Residential Development at
Collins Avenue, Co. Dublin

Combined Stage 1 & 2
Road Safety Audit

Document Ref: P21-090-PSW3-RP-001

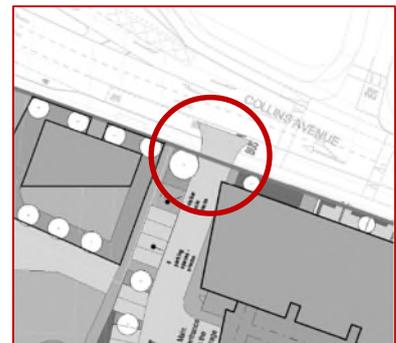
Summary: No junction control or priority type has been indicated at the development access.

The junction control (stop, yield etc.), and subsequently priority, at the proposed development access has not been indicated. This could increase the risk of overshoot collisions where drivers fail to slow and stop when exiting the development's access.

Ensure the junction control at the development access is clear (via signage/road markings) to drivers exiting the development.

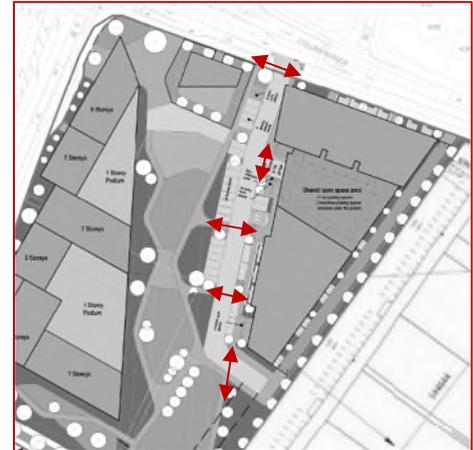
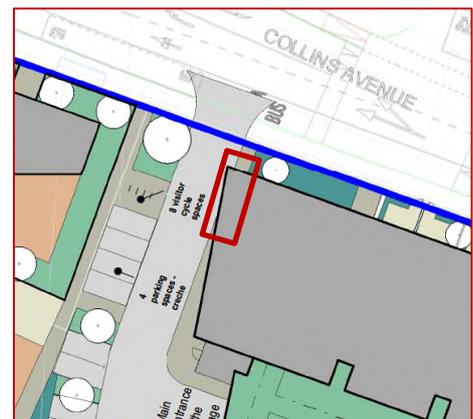
Summary: No tactile paving provision within the development.

Formal pedestrian crossing points, including dropped kerbs and tactile paving, have not been indicated within the development. A failure to provide dropped kerbs at crossing points and along pedestrian desire lines could result in mobility impaired pedestrians being unable to safely and independently enter the carriageway to cross to the opposite footpath. This could result in slips, trips or falls as these pedestrians attempt to descend the kerb. Similarly, a failure to provide tactile paving at dropped kerb locations could lead to an increased risk of visually impaired pedestrians unintentionally entering the carriageway where they could be struck by vehicles.

Formal uncontrolled pedestrian crossings, including dropped kerbs and tactile paving, should be provided at pedestrian crossing points/desire lines.
